Wisconsin Department of Transportation CONTRACT MODIFICATION JUSTIFICATION

CONTRACT ID: 20180911005	CONTRACT MODIFICATION NO: 026
PROJECT ID: 2250-12-70	FEDERAL ID: WISC 2018375
HIGHWAY OR LOCAL ROAD: STH 20, STH 83	COUNTY: Racine
PROJECT DESCRIPTION: Main St/1 st St Vil of Waterford; Buena Park Rd to Milw Ave (STH 36)	
MANAGING OFFICE: Jacobs	LOCAL PROGRAM: <input type="checkbox"/>
PRIOR APPROVAL REQUIRED: <input checked="" type="checkbox"/> YES <input type="checkbox"/> NO (If applicable attach additional justification.)	
Attached Contract Modification <input type="checkbox"/> Other Supporting Documentation Attached <input type="checkbox"/>

This is a no cost change order which describes the need to extend the contract completion date due to unforeseen issues occurring from adverse weather, utilities, staging, and other design deficiencies.

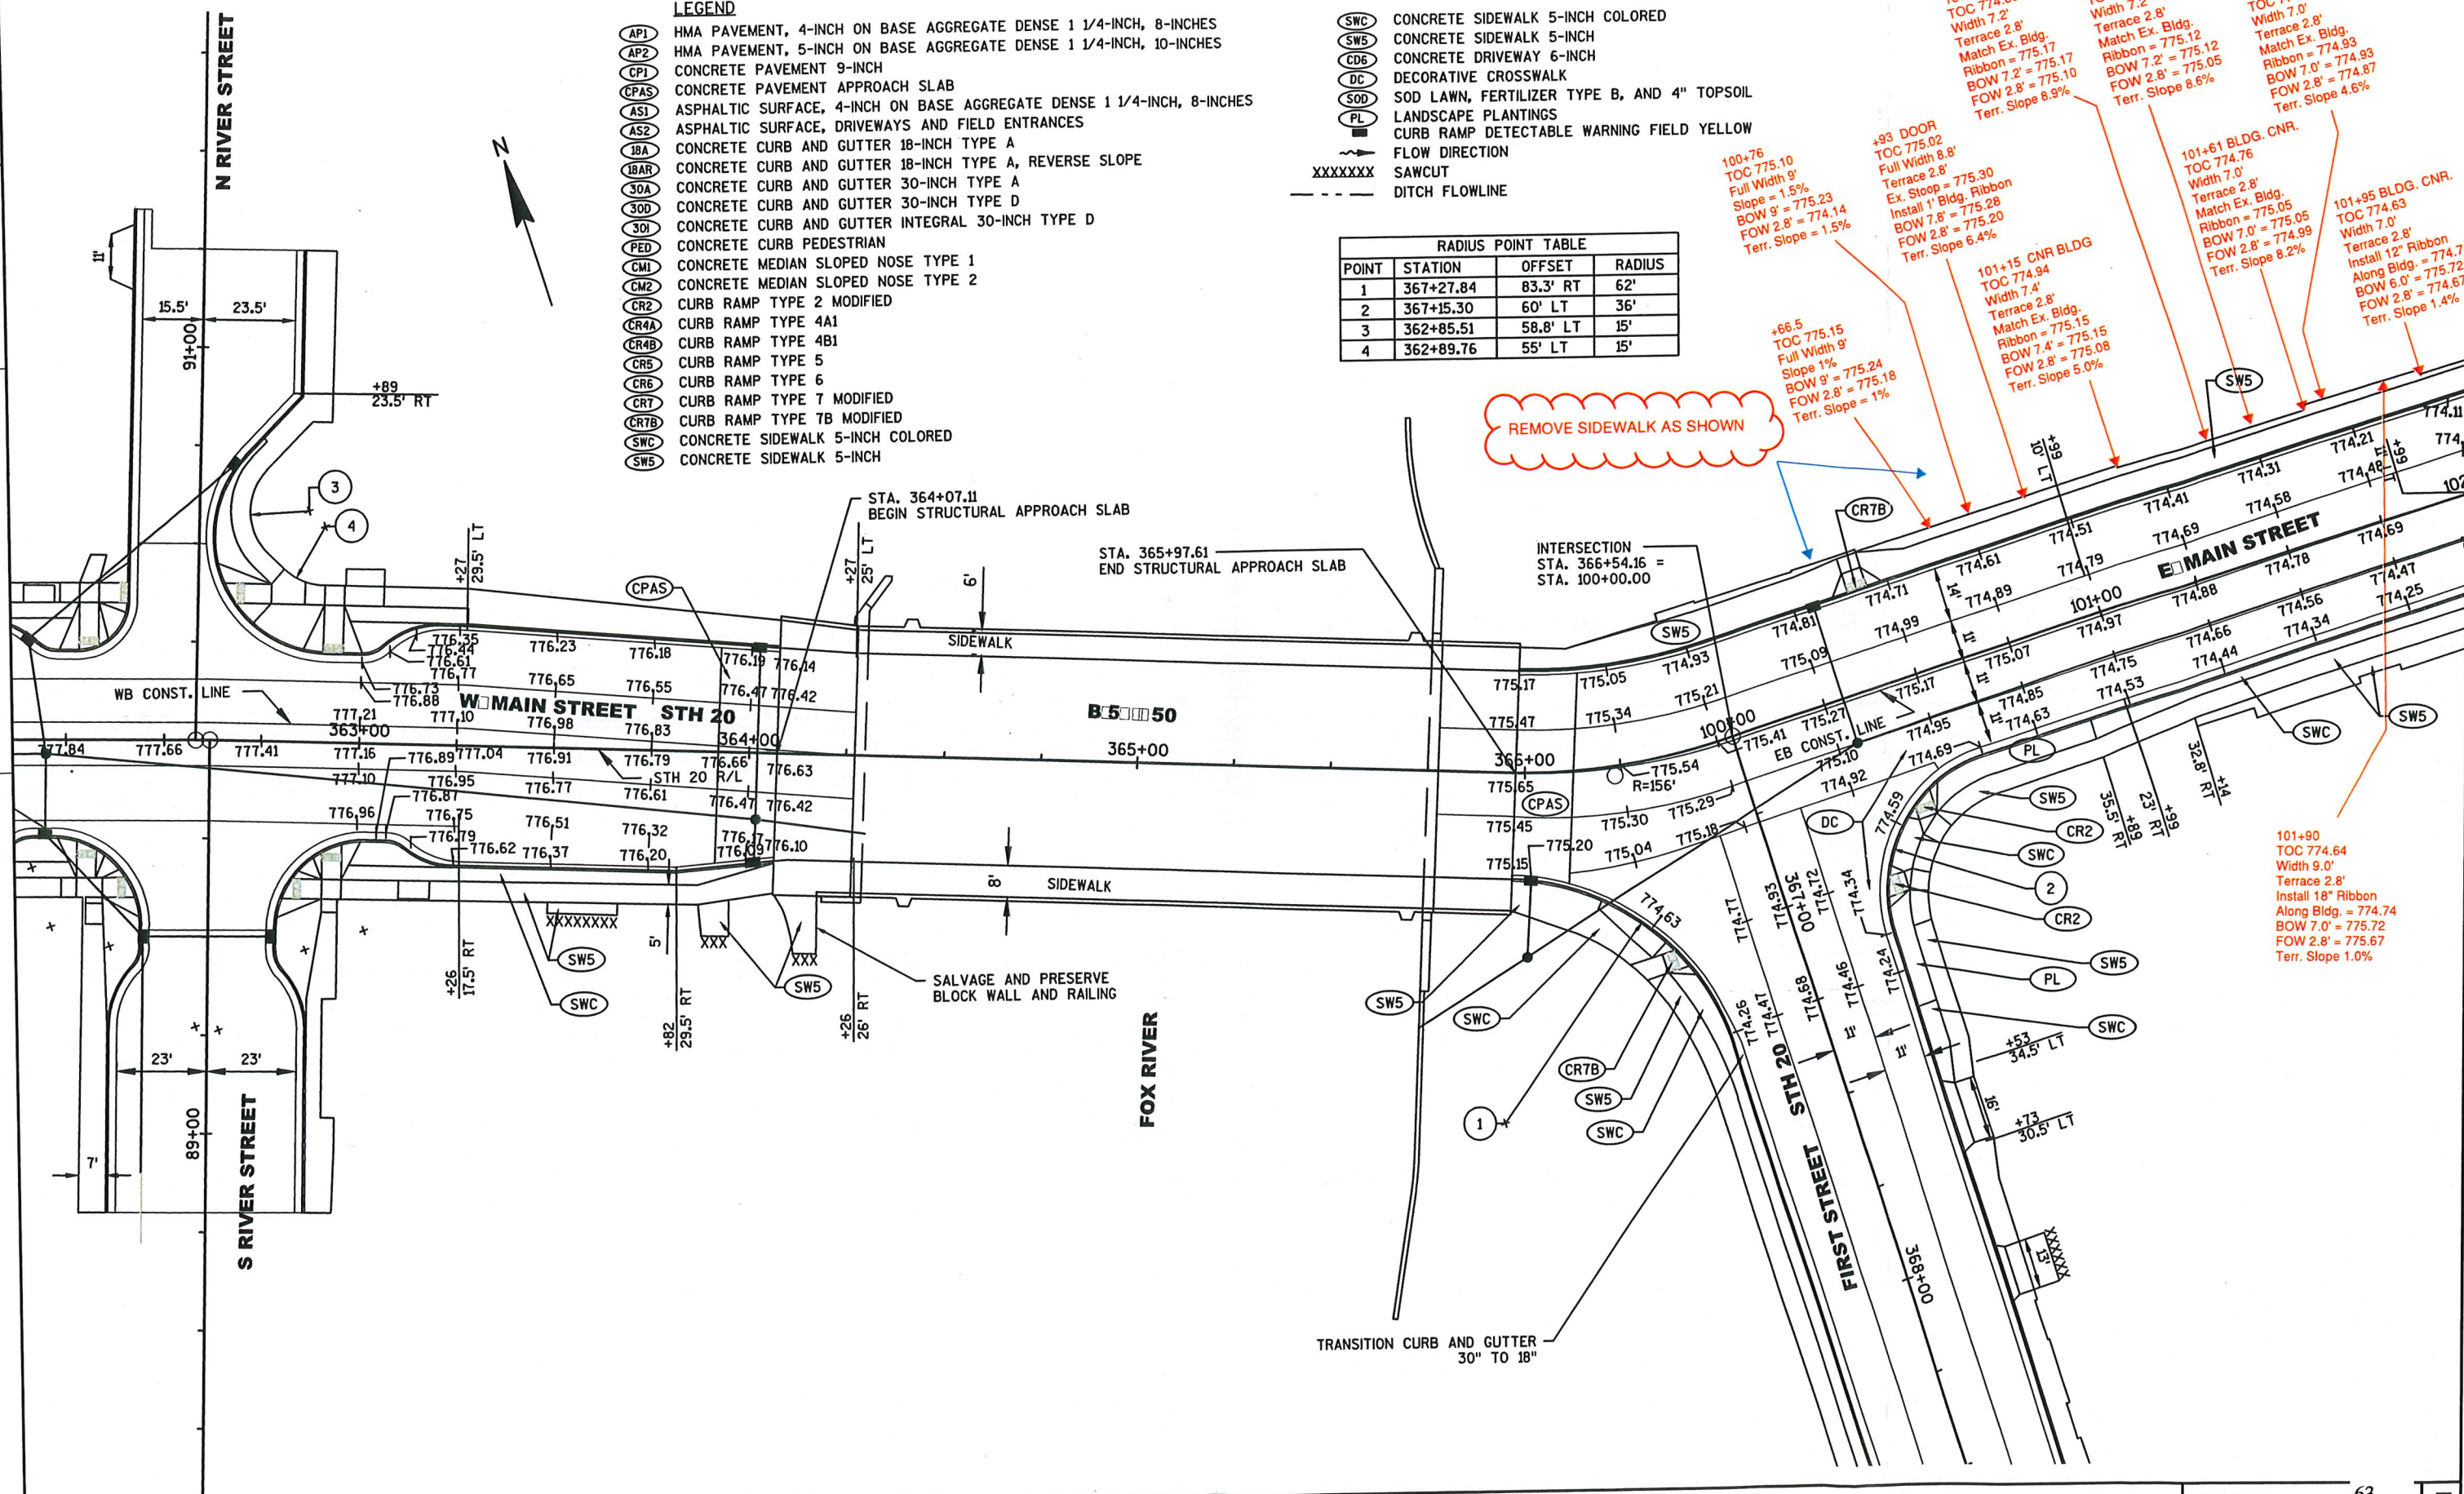
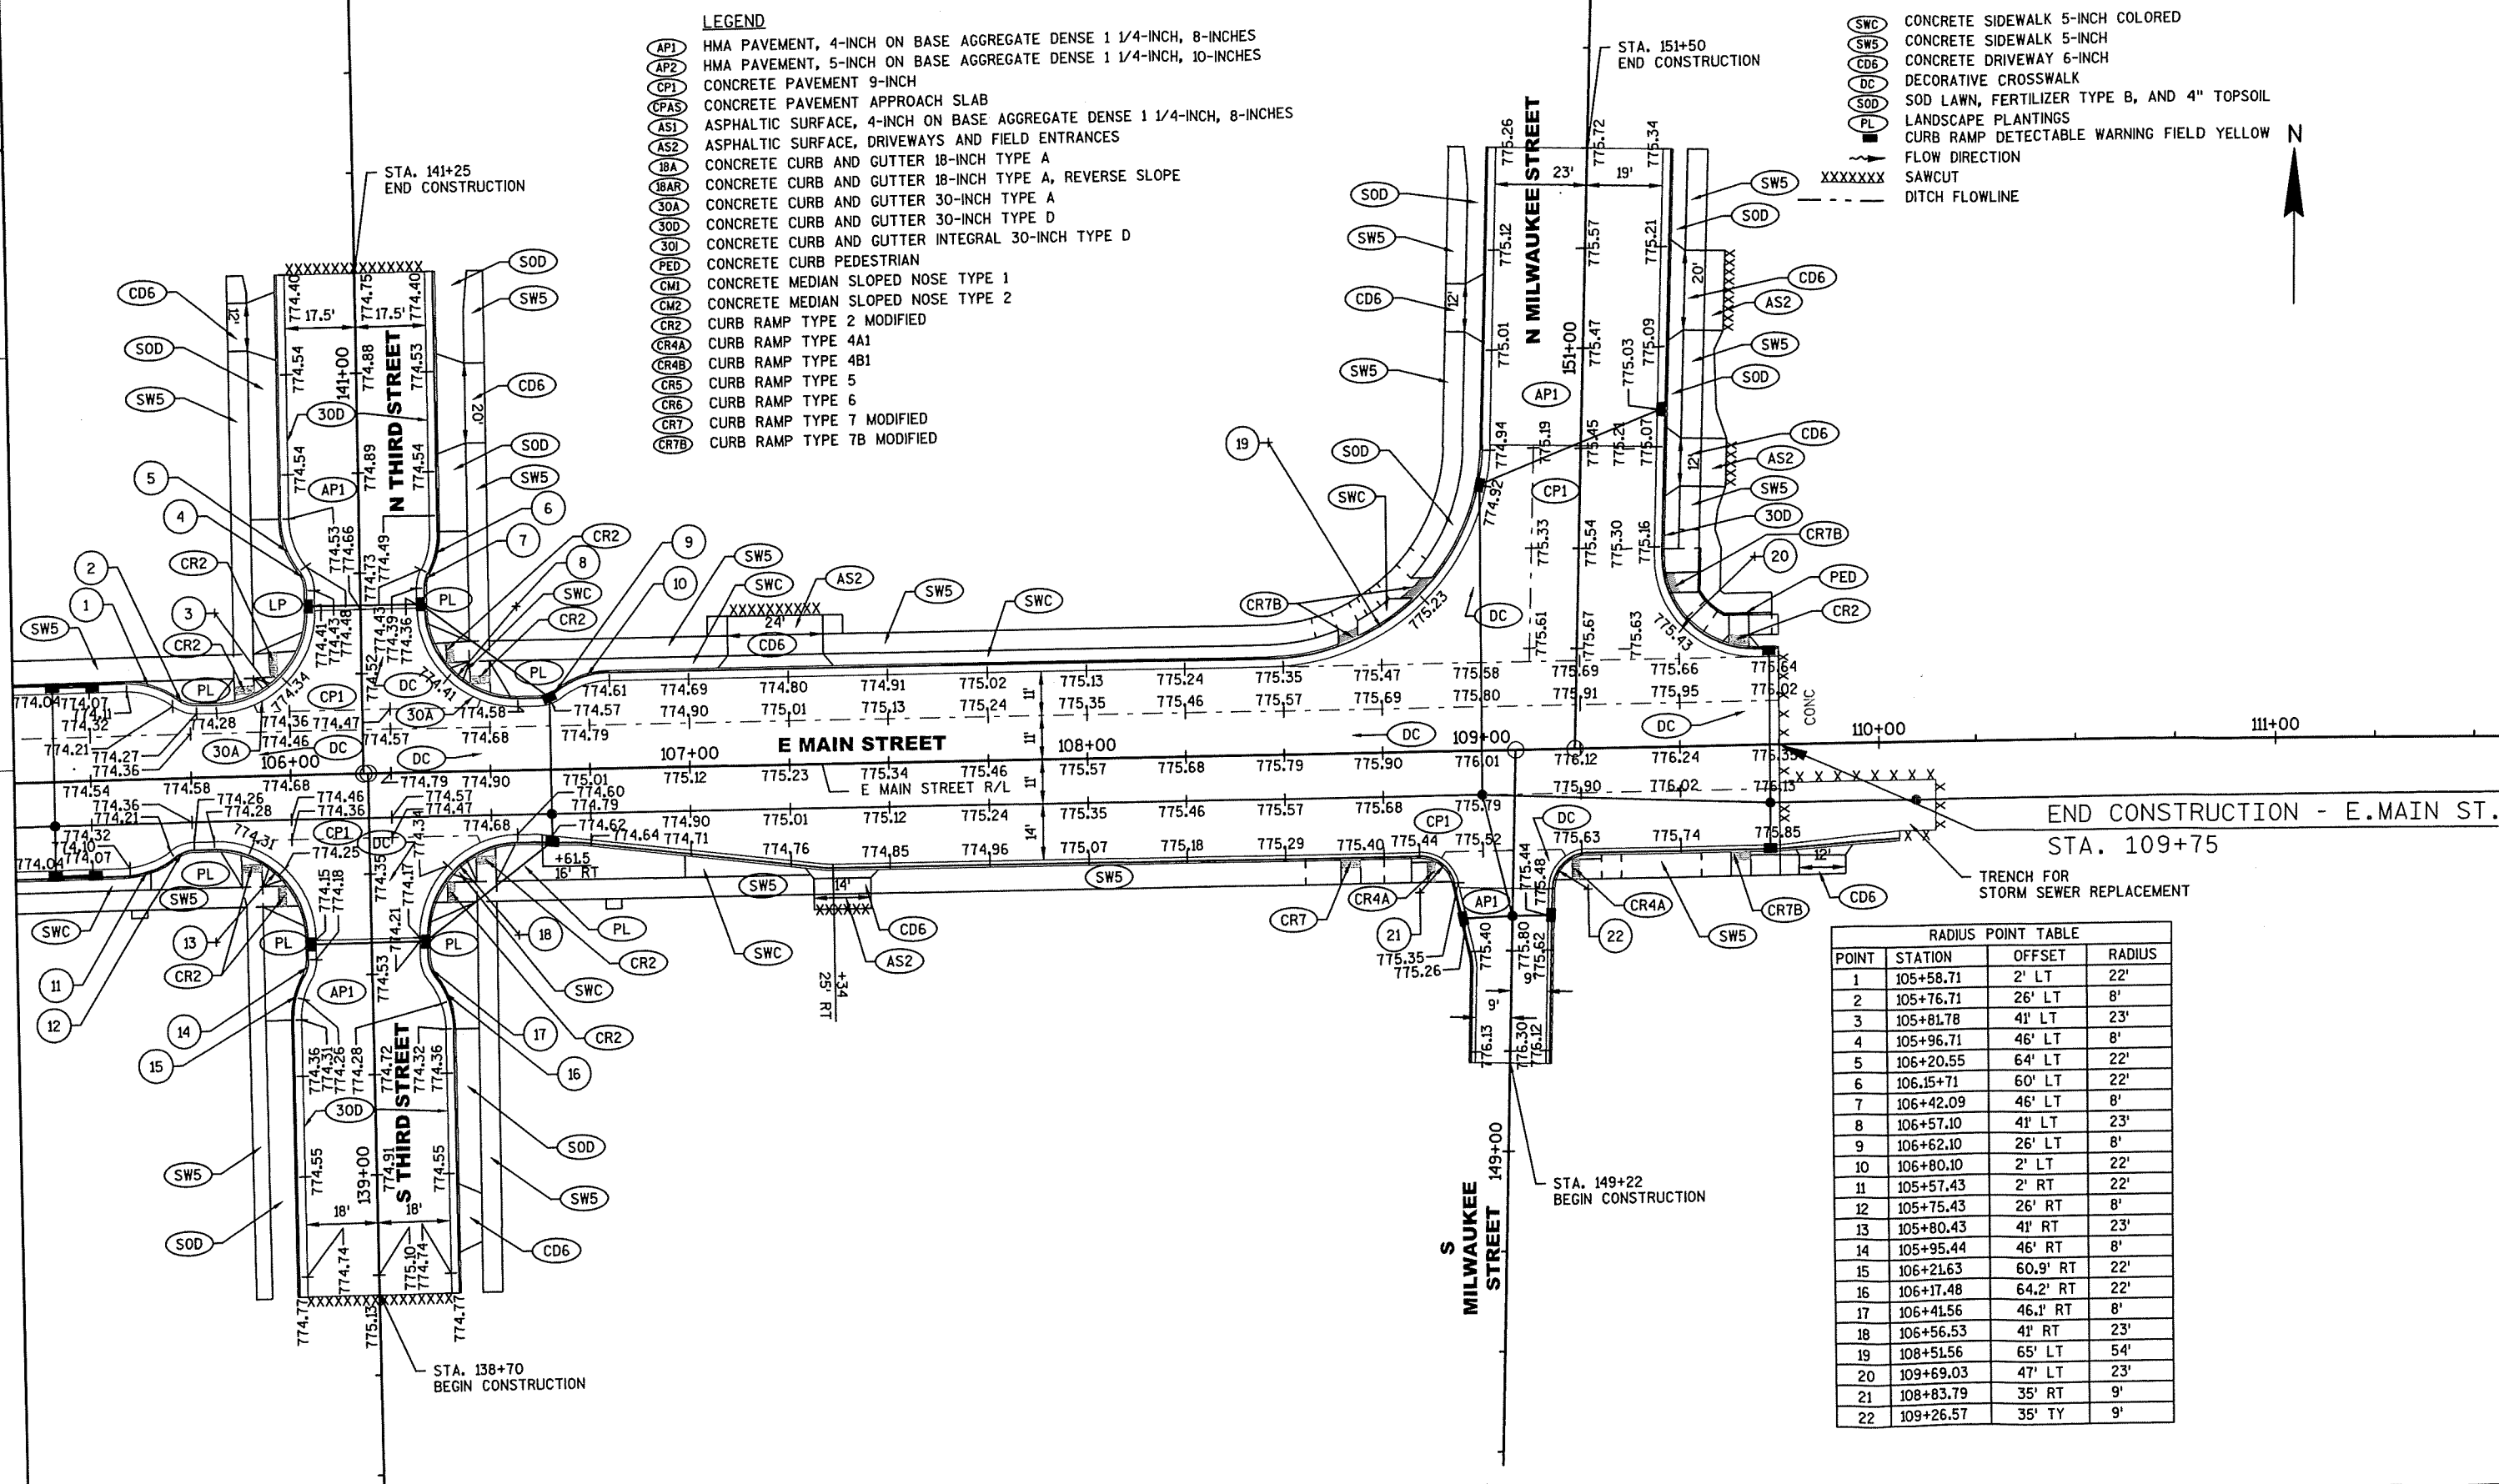
We will need to add pedestrian curb to the contract as there will be areas where we can't meet ADA requirements without it.

See attached RFI for proposed sidewalk grades through downtown on north side.

Downtown Waterford Sidewalk Grades and ADA Compliance: On October 10, 2019 it was discovered that some areas of downtown sidewalk if constructed per plan would not be ADA compliant. At the request of the DOT project manager, it was requested that the contractor perform construction survey and design the sidewalk by revising grades to meet ADA requirements. Approval of their design on October 23, 2019 resulted in added pedestrian curb resulting in extra work. The design-build effort on the contractor postponed sidewalk construction which was controlling. **The contractor is excused 14 working days.**

Please move forward with this plan. Please have Dolson submit a price for this inlet work at the NW Quad of 2nd Street. Please utilize item the original contract item 601.0600 Concrete Curb Pedestrian.
